DPD ZONING SUBMITTAL FOR PORTION OF BLOCK 3 OF MILWAUKEE BUCKS ARENA DEVELOPMENT - GPD

**THE PROPOSED VENUES ARE EXACTLY WHAT  
THE CITY'S PLANNING HAS ATTEMPTED TO PREVENT**  
(Highlighted provisions are quoted directly from current standards)

**A5** FIRST FLOOR TRANSPARENCY PLAN  
1/16" = 1'-0"

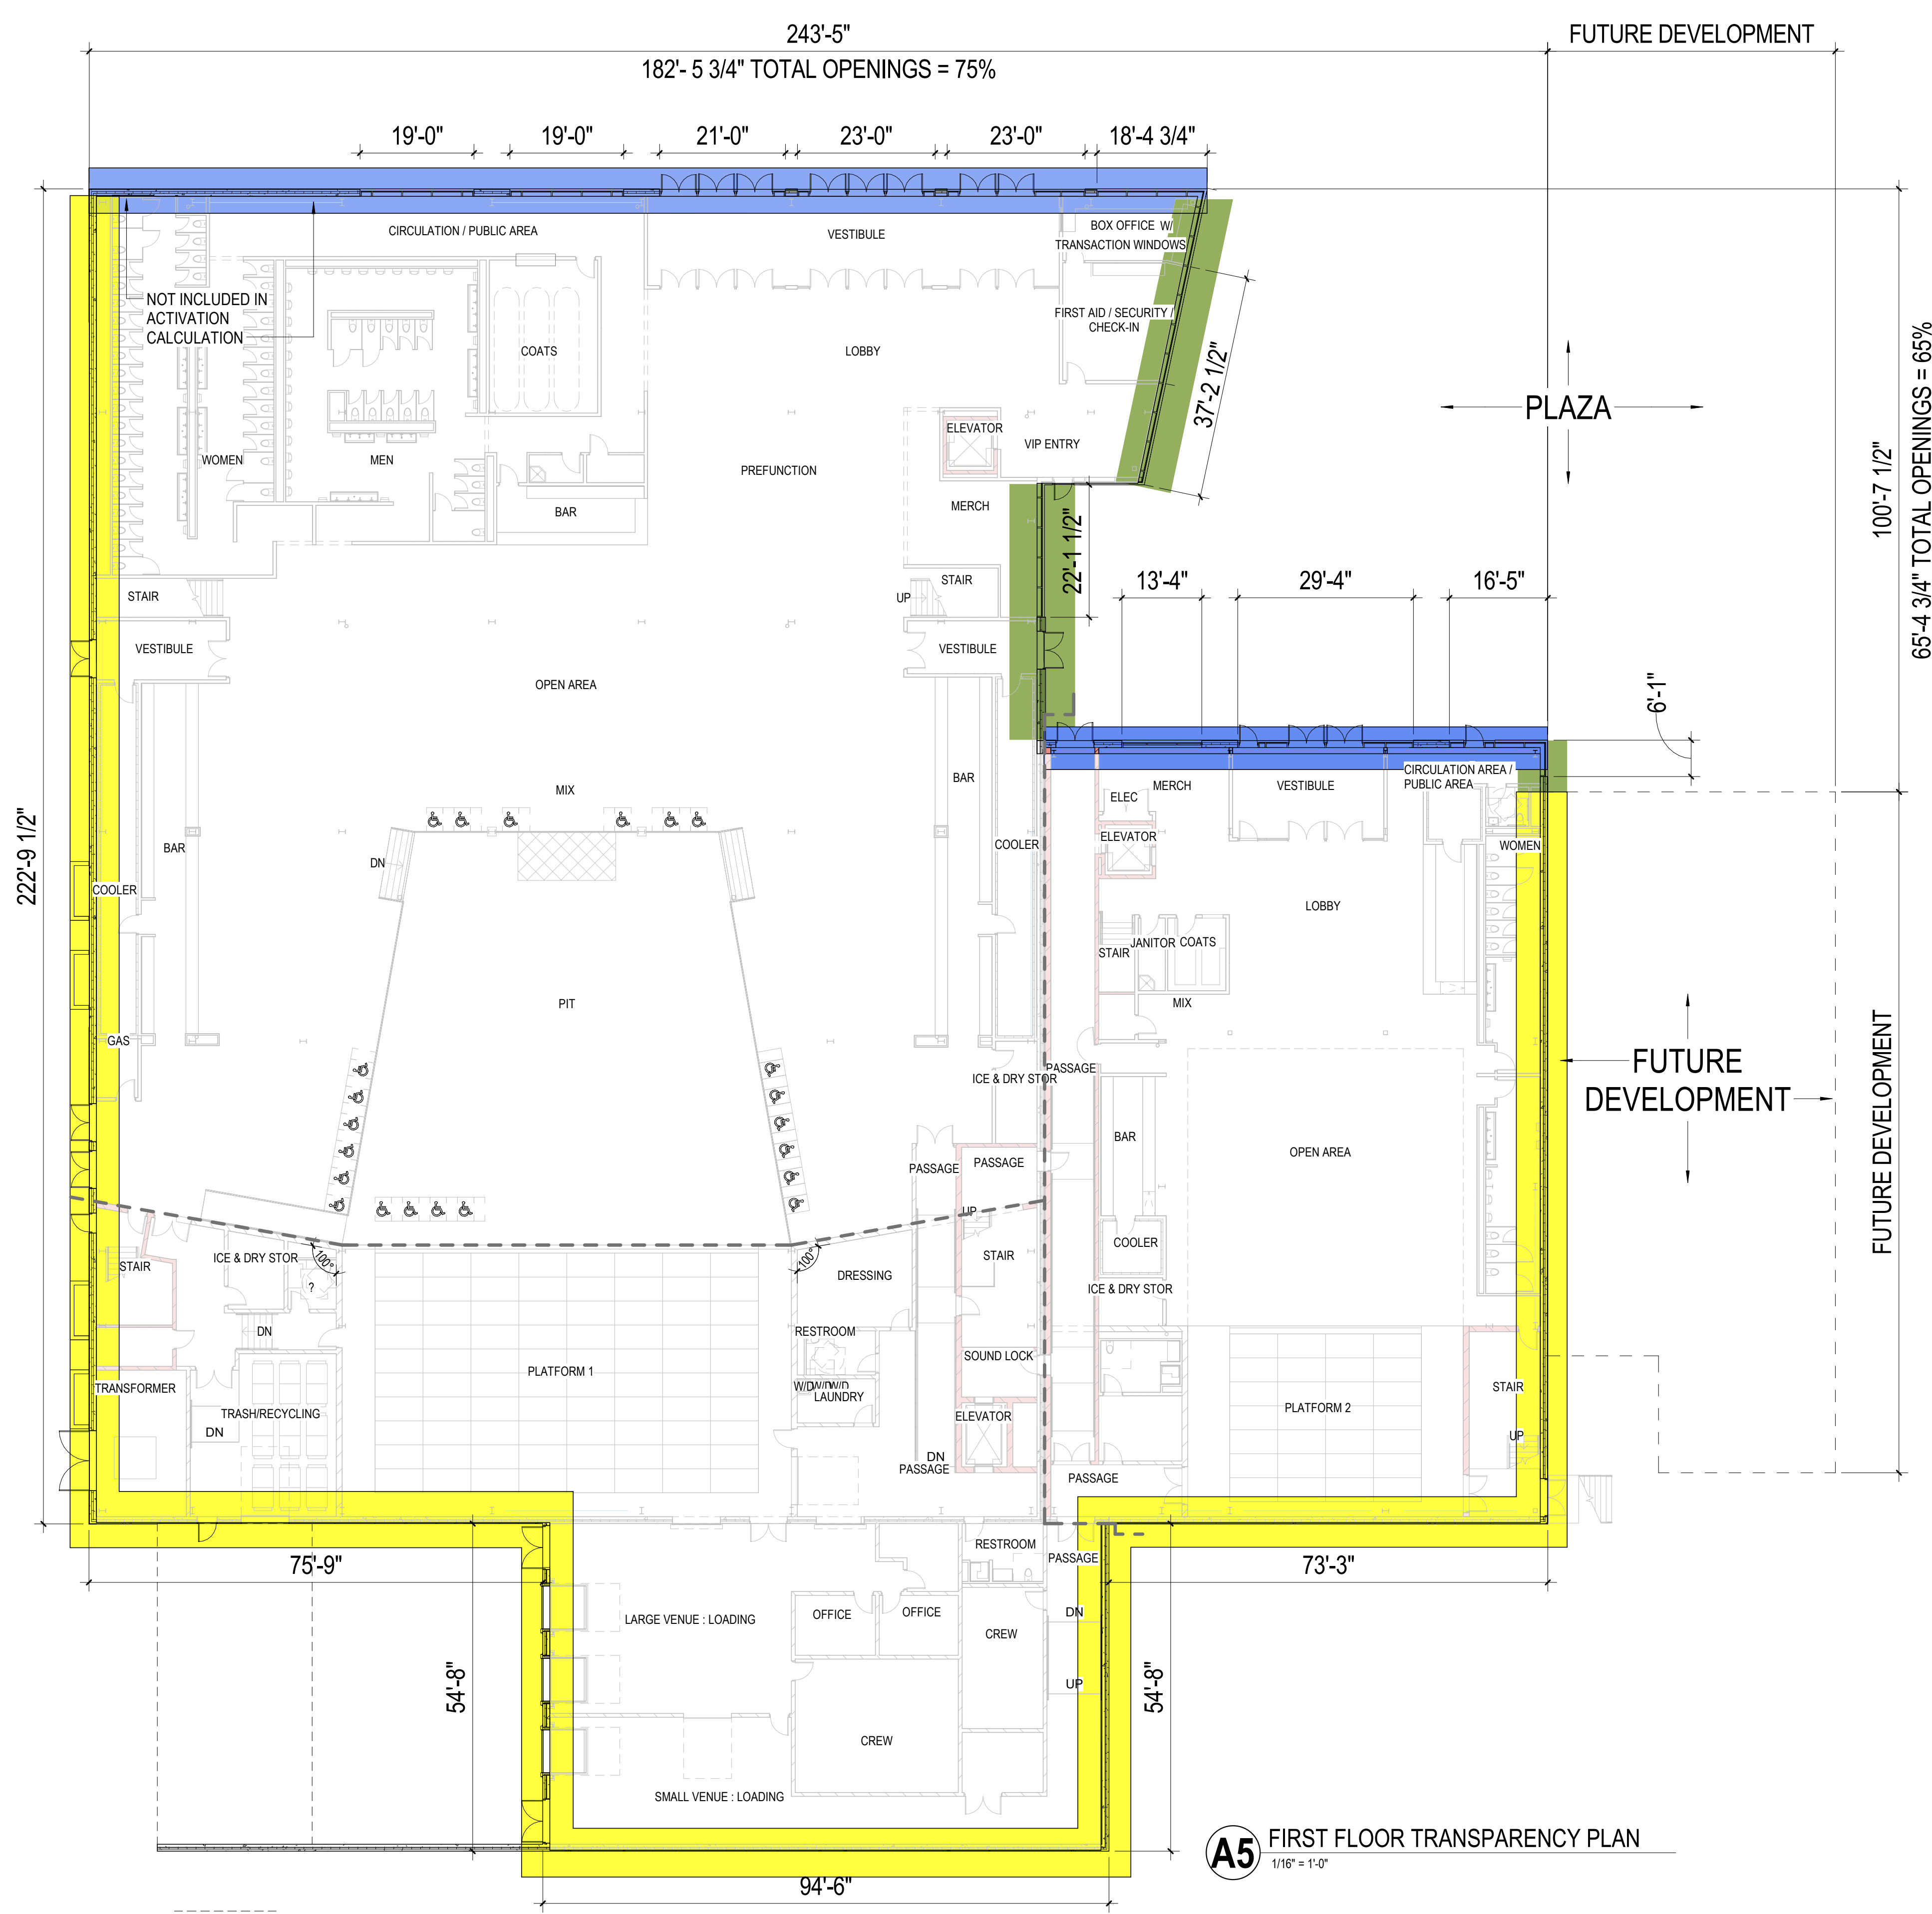
Is a large blank wall, or the use of the property to compete with Turner Hall, sympathetic to Turner Hall?

- The 48-foot setback, the lack of buildings fronting on James Lovell and the flat, windowless wall facing east are precisely what the city does not want. This proposal fails to meet the following goals and values of the GPD:

- By moving the building back 48 feet, the developer is attempting to totally avoid the following requirements of the GPD. In the process, the nature of the neighborhood will be totally different than the urban, street activated plan of the city.
